PROJECT: Ferndale Terrace Project

City Project SW2016-01; TIB Project Number 8-2-985(011)-1

ADDENDUM NO. 1
To the Contract Documents for:
City of Ferndale, Washington
FERNDALE TERRACE PROJECT
City of Ferndale Project No. SW2016-01; TIB Project Number 8-2-985(011)-1

DWG 18023 EX COND		DATE 1/17/25
JOB# 18023	SCALE H: 1' = 20' V: 1' = 2'	SHEET 6 of 85

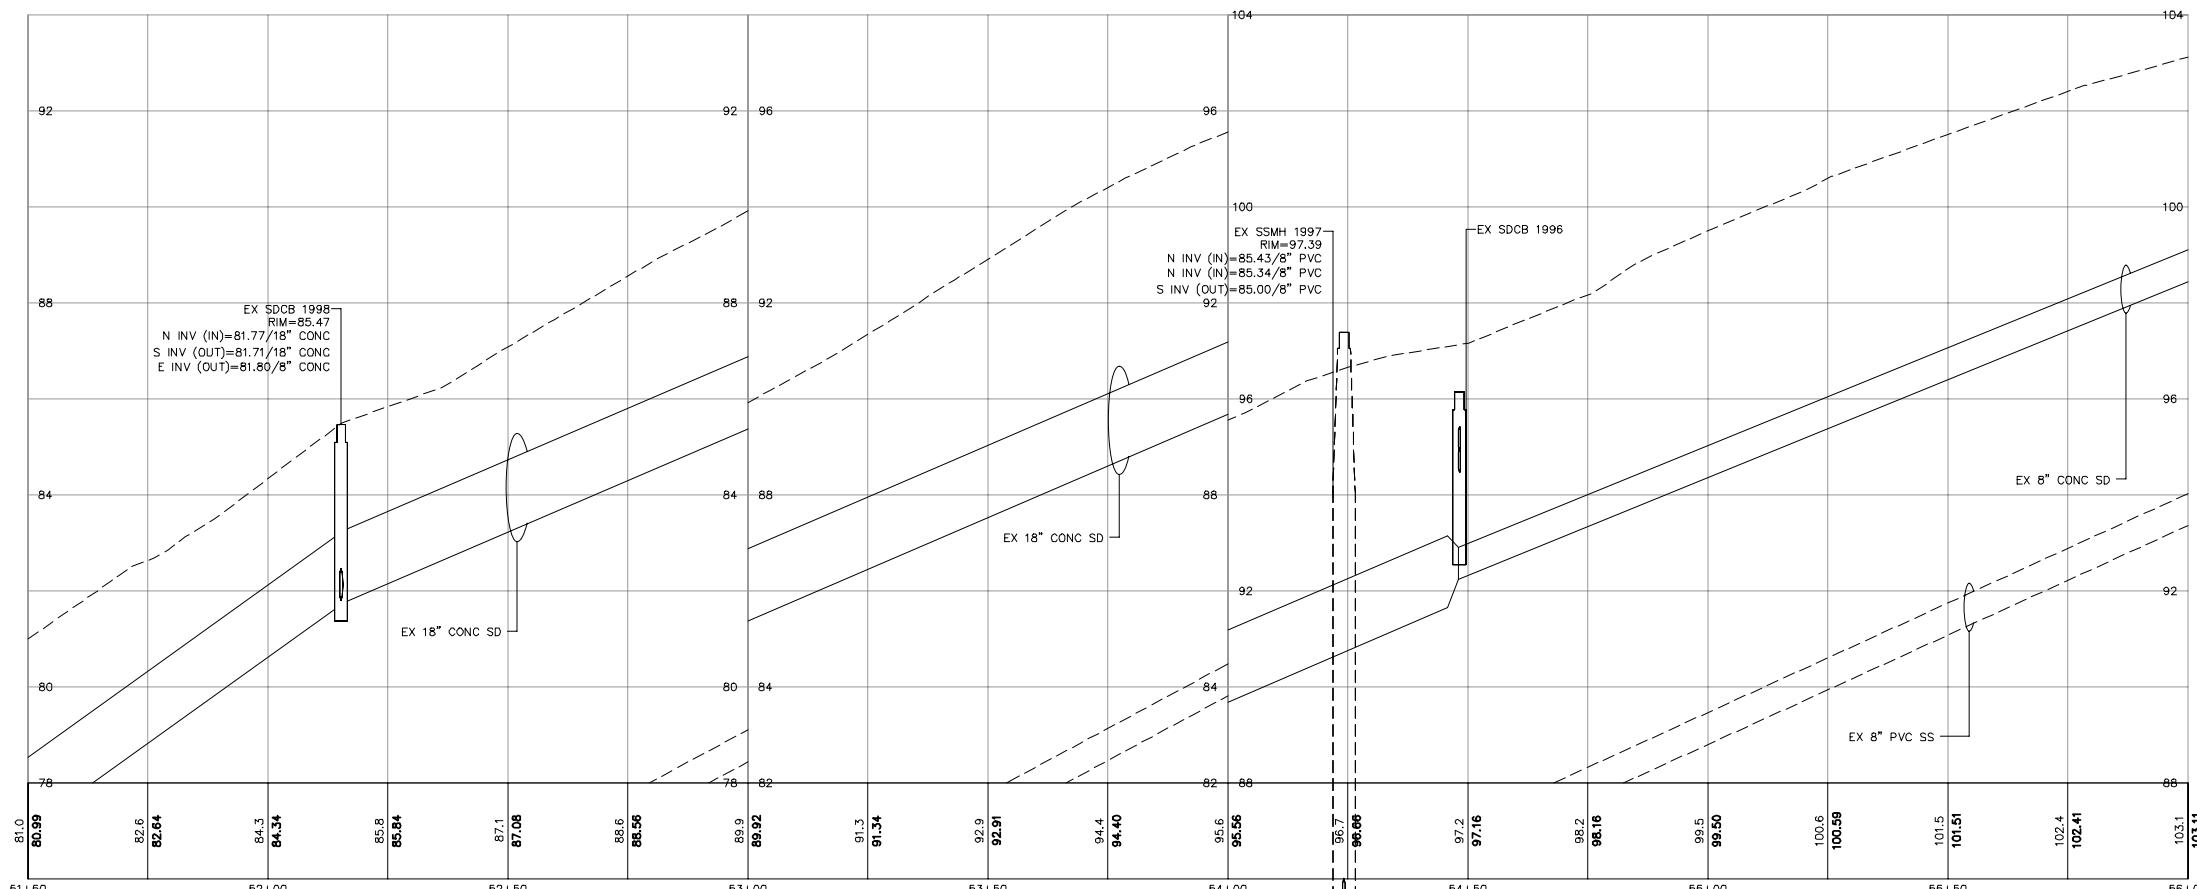
Sheets 6 through 11, existing contour labels added.

ADDENDUM NOTE:
CONTOUR LABELS ADDED TO EXISTING CONTOURS ON
SHEETS 6 THROUGH 11.

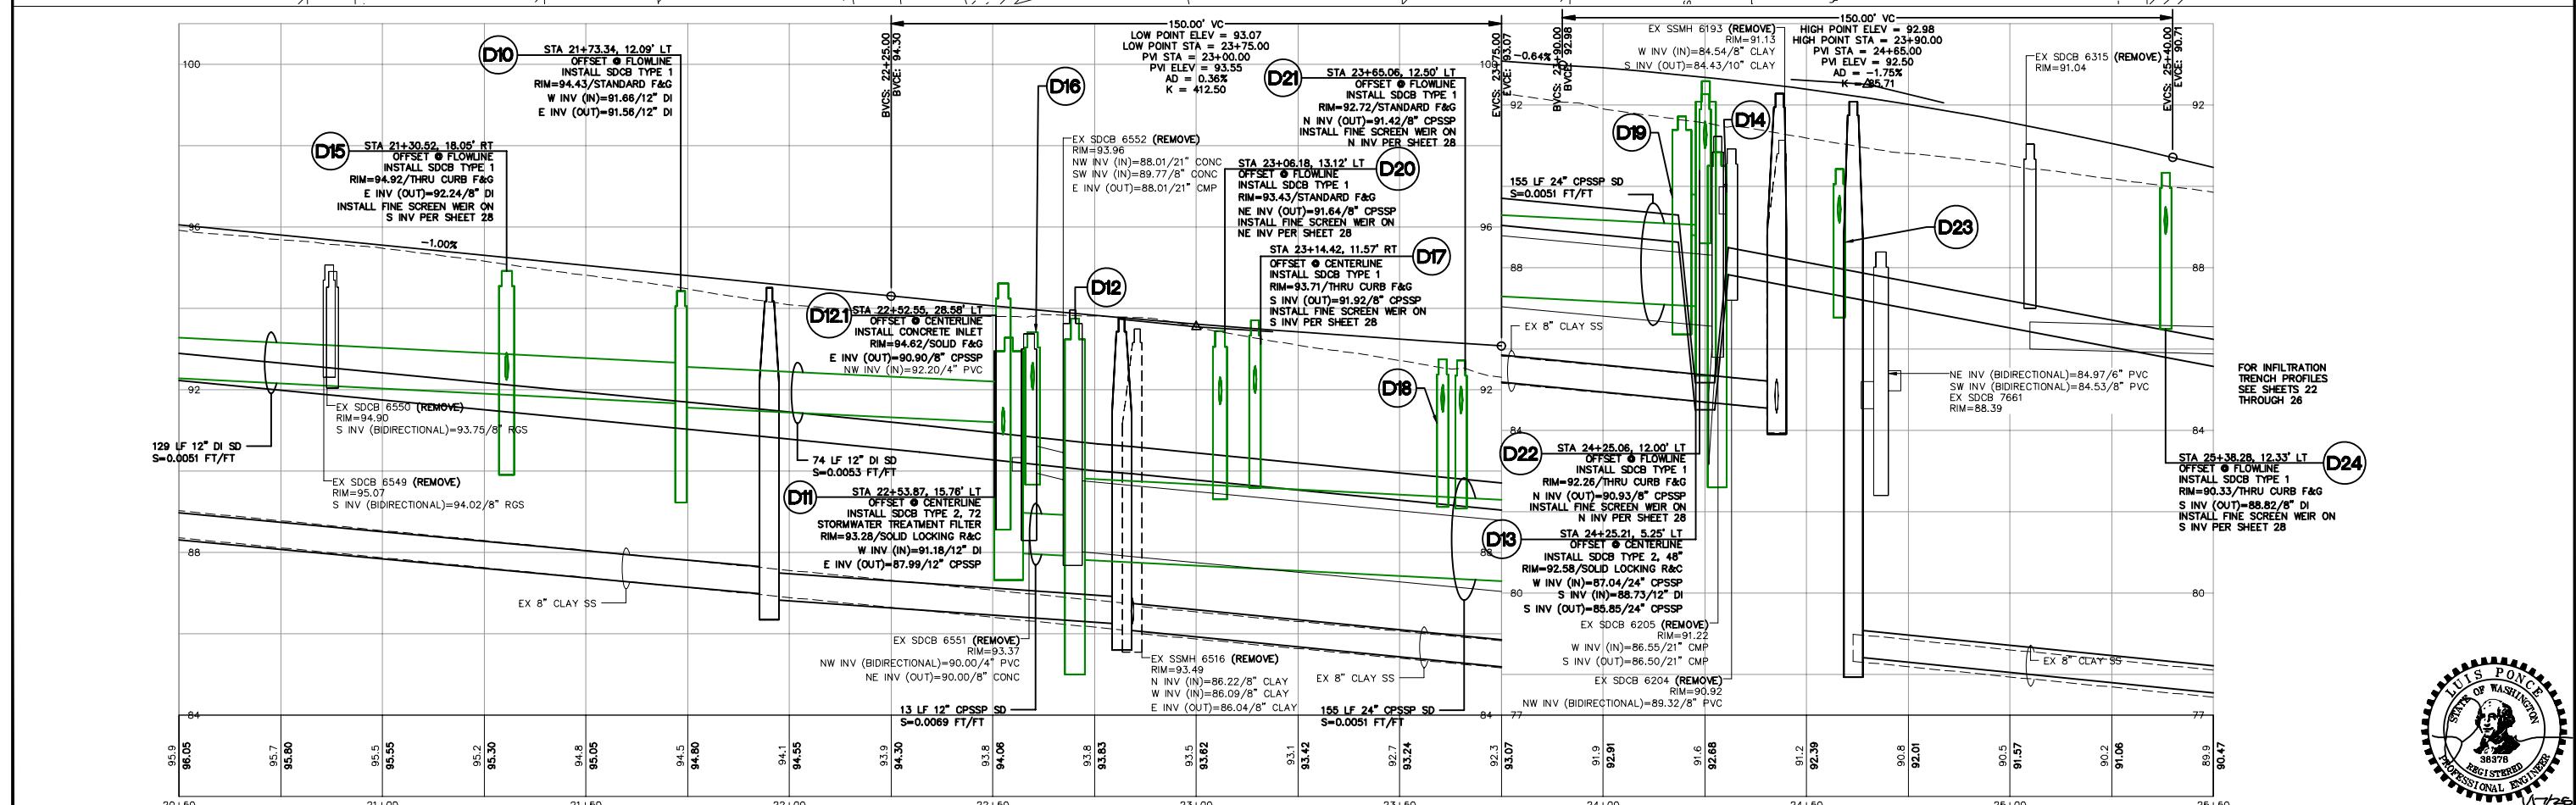
Sheet 17, catch basin D23 moved south and pipe connecting D23 and T3.1 lengthened accordingly.

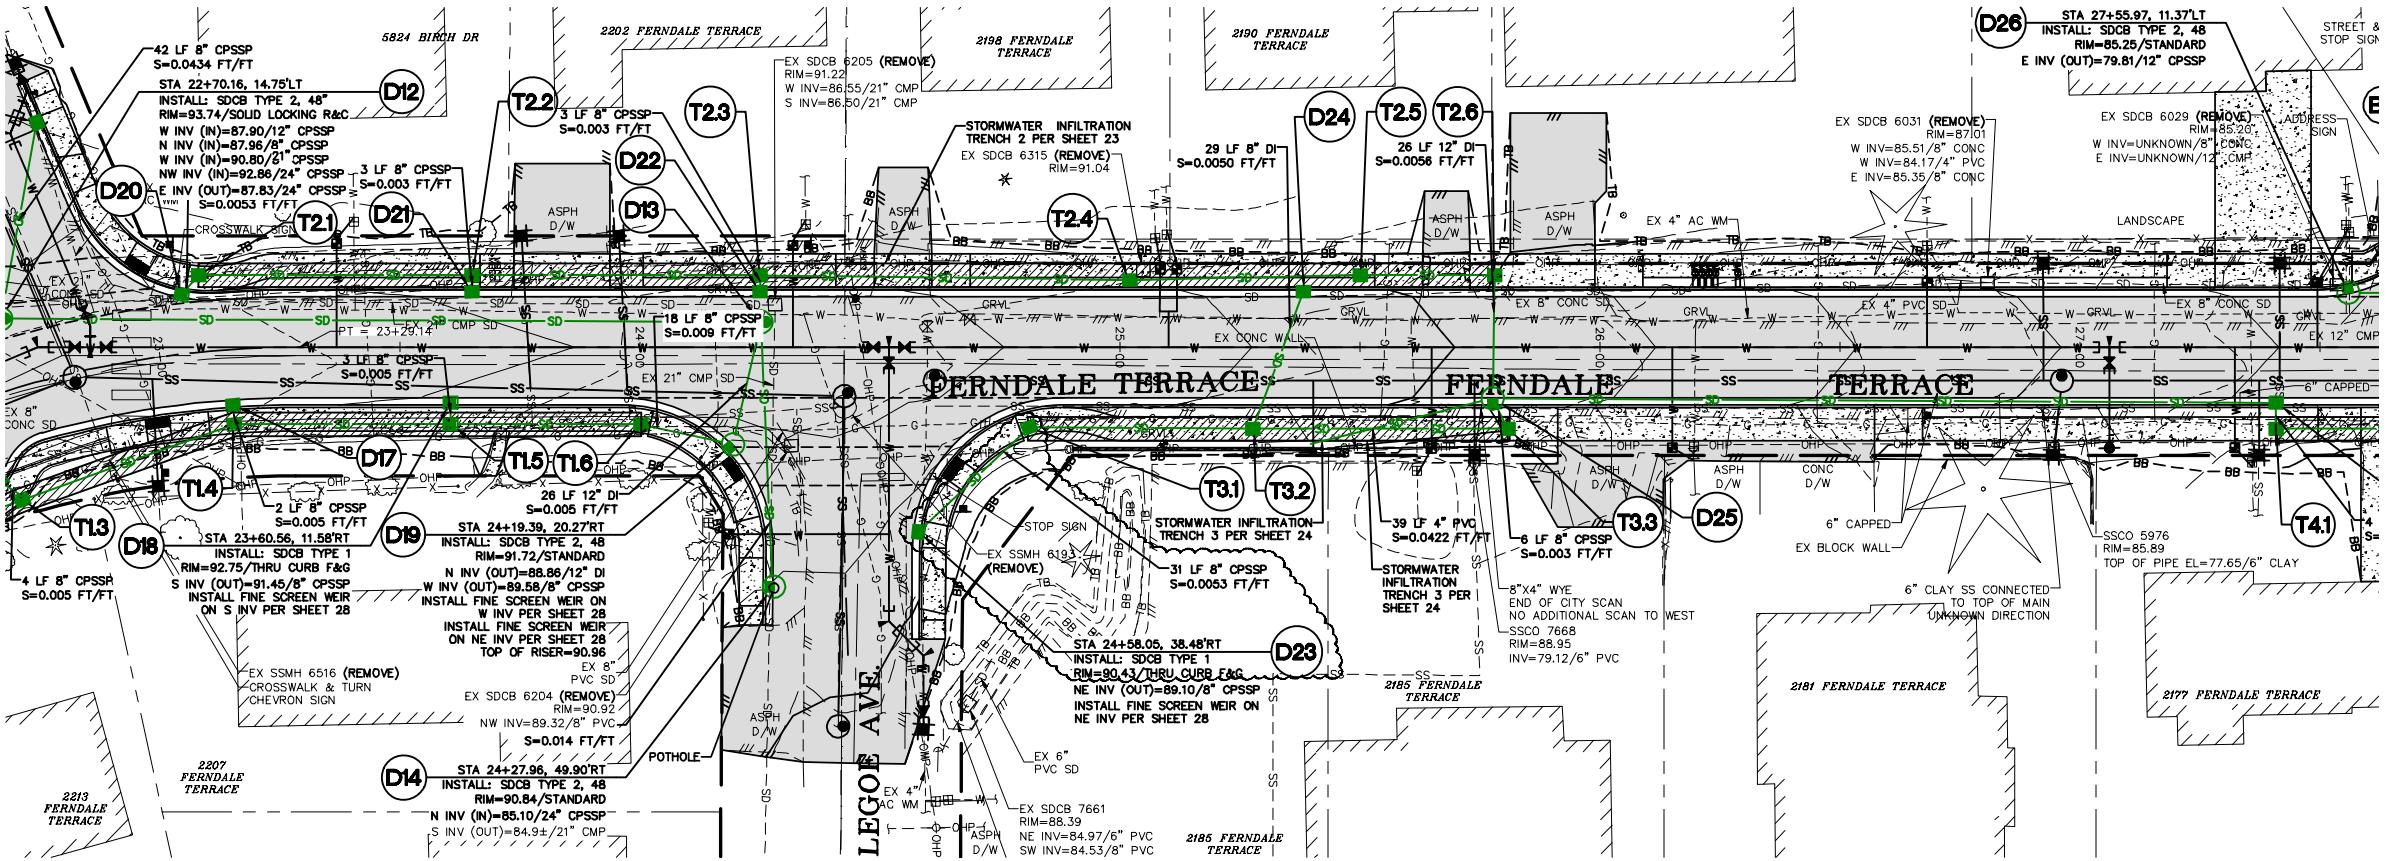
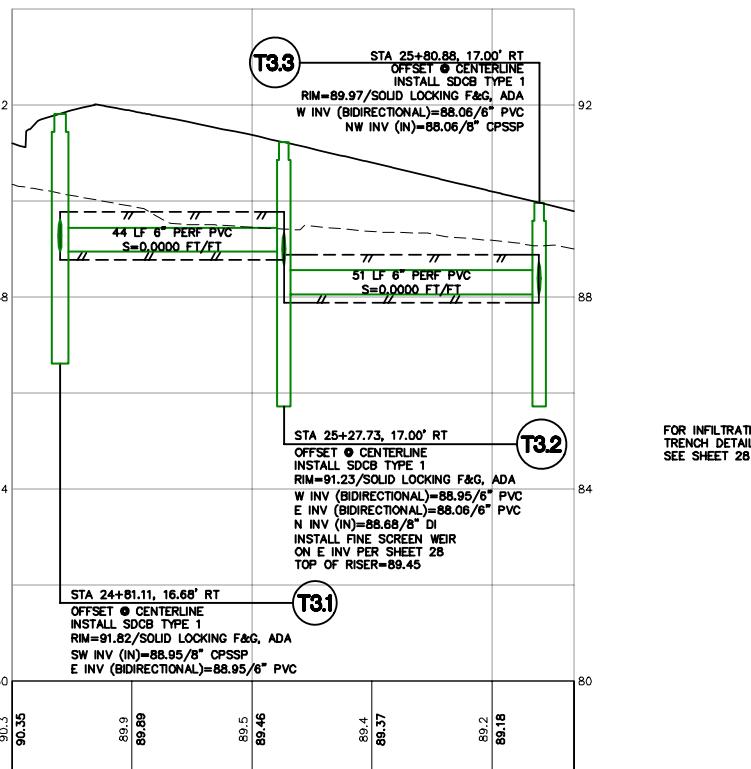
Sheet 24, catch basin D23 moved south and pipe connecting D23 and T3.1 lengthened accordingly.

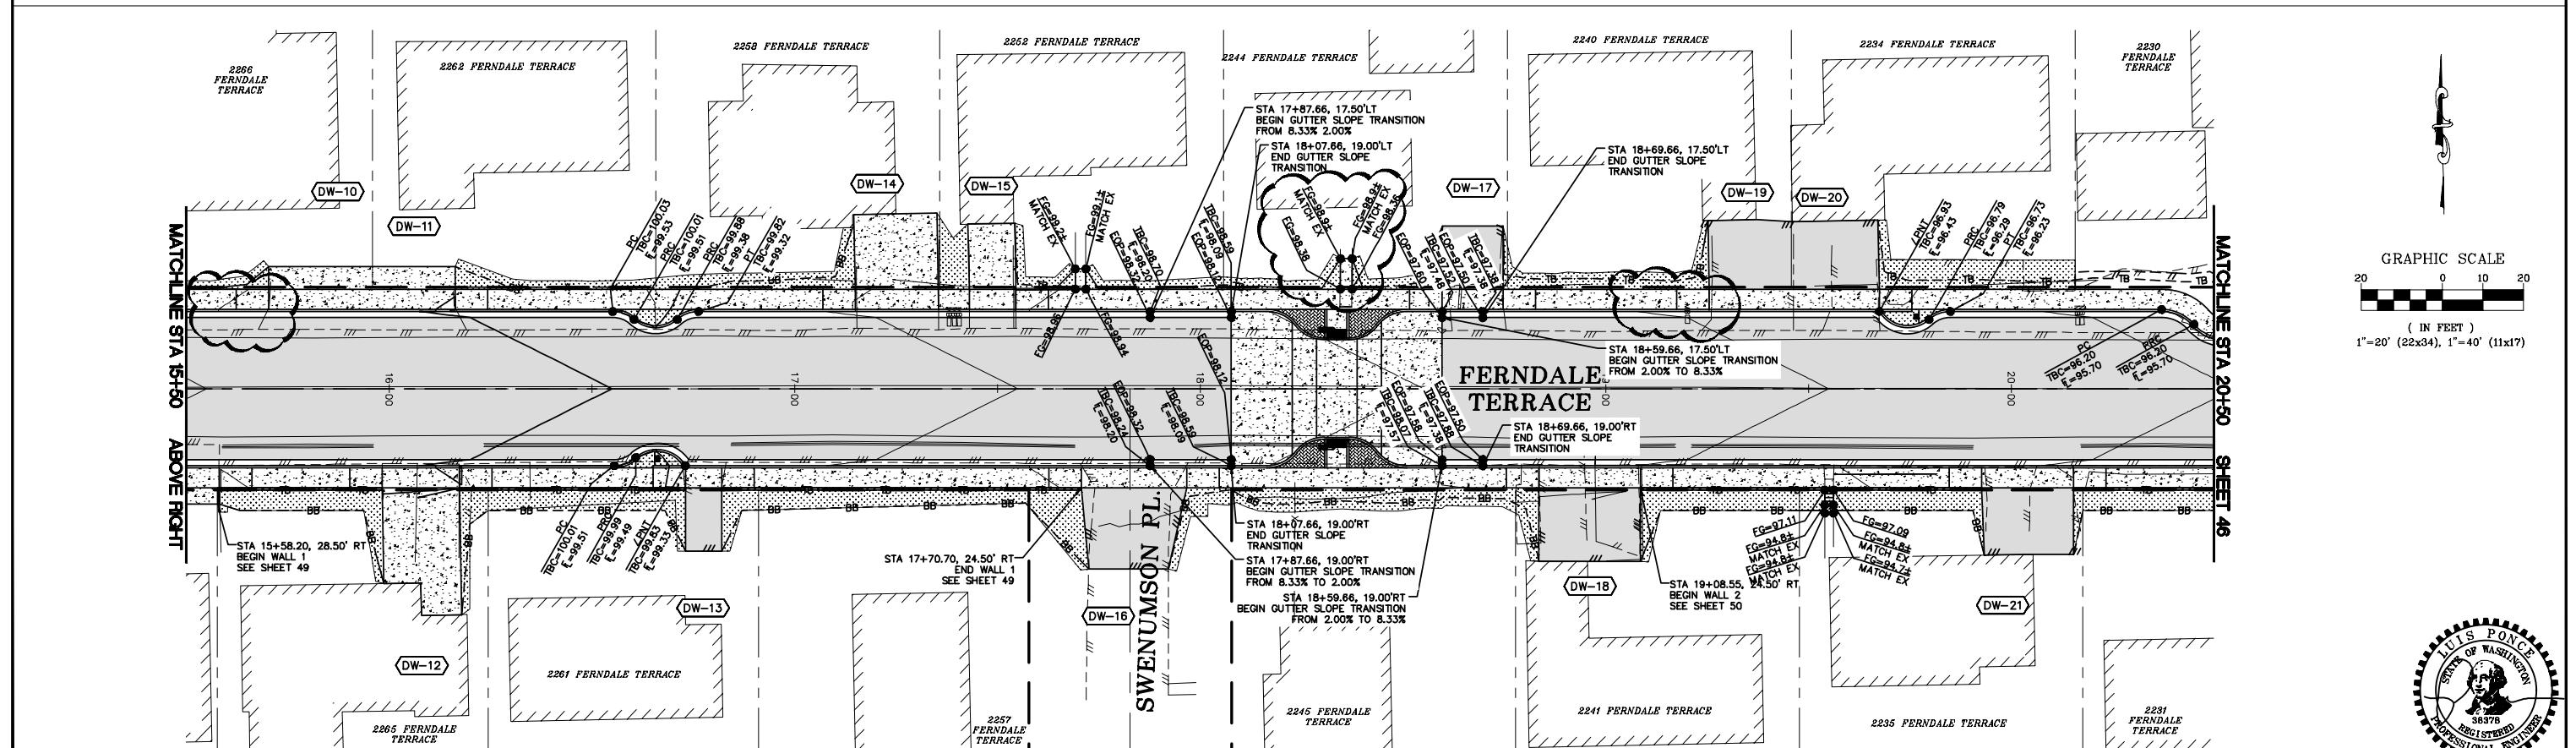
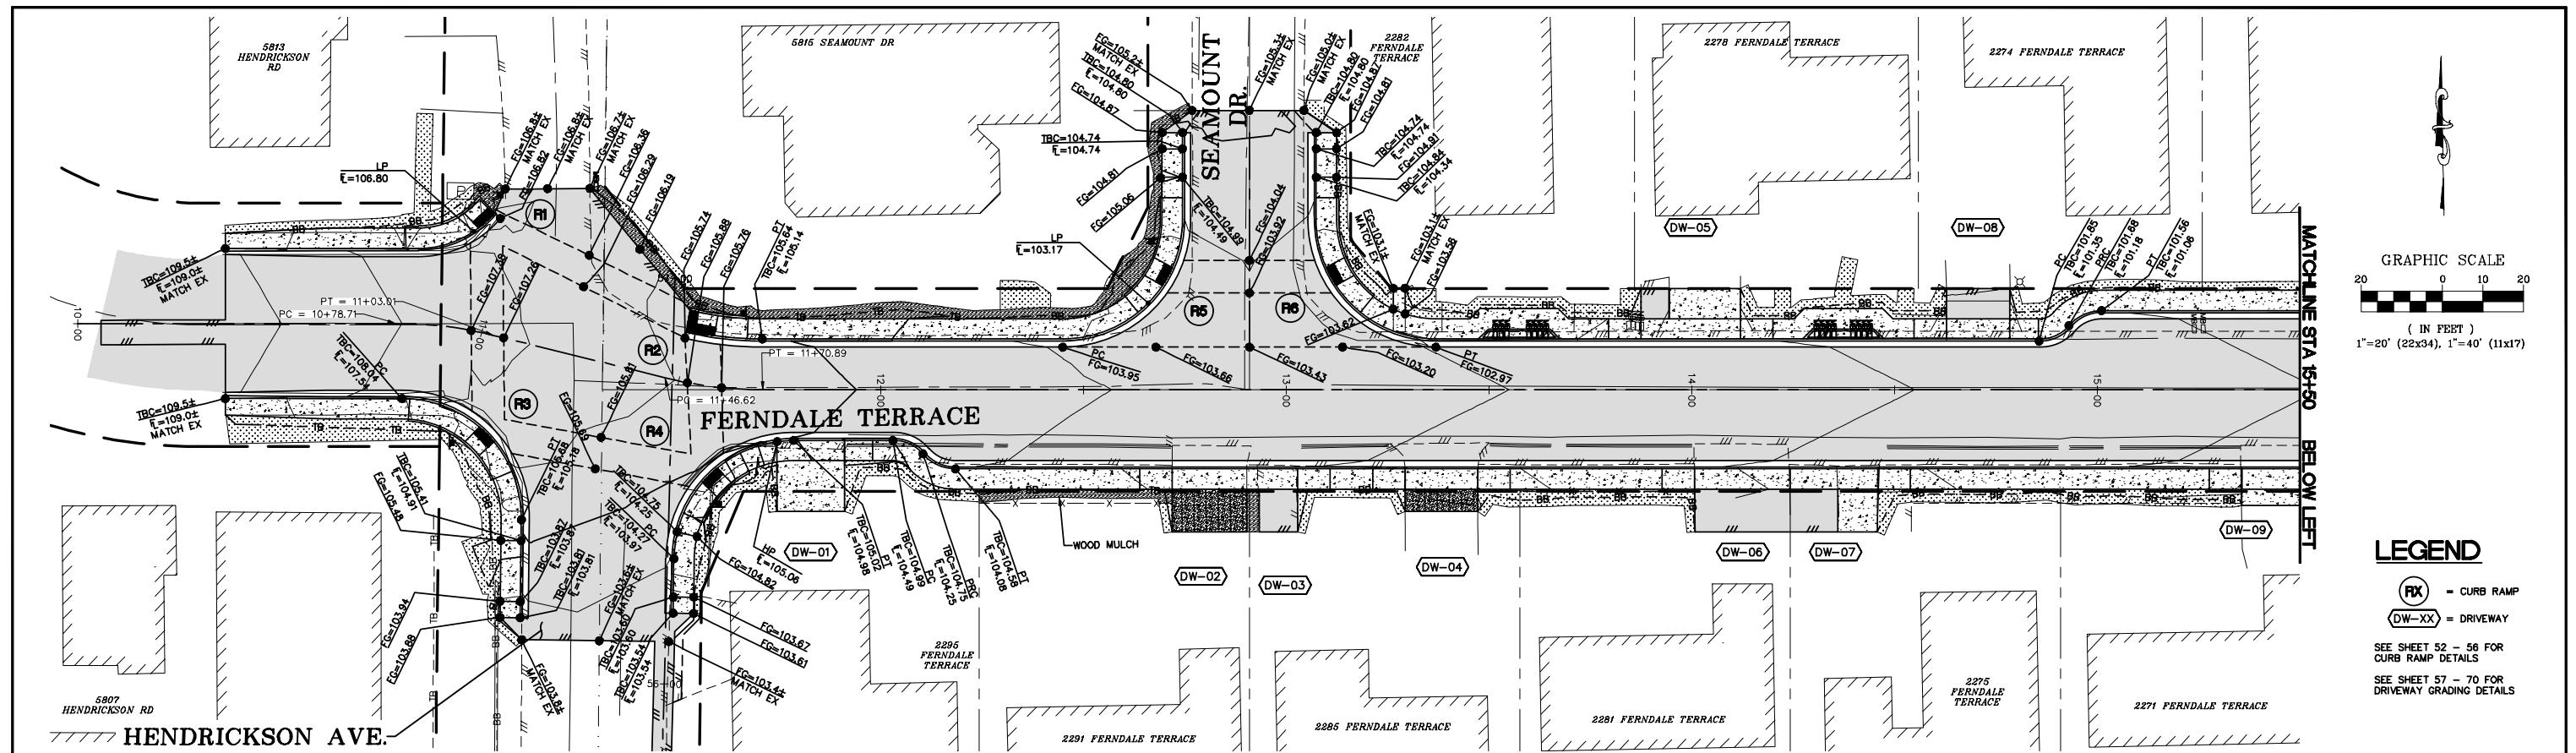
Sheet 45, two curb bulb outs removed and private sidewalk grading updated.
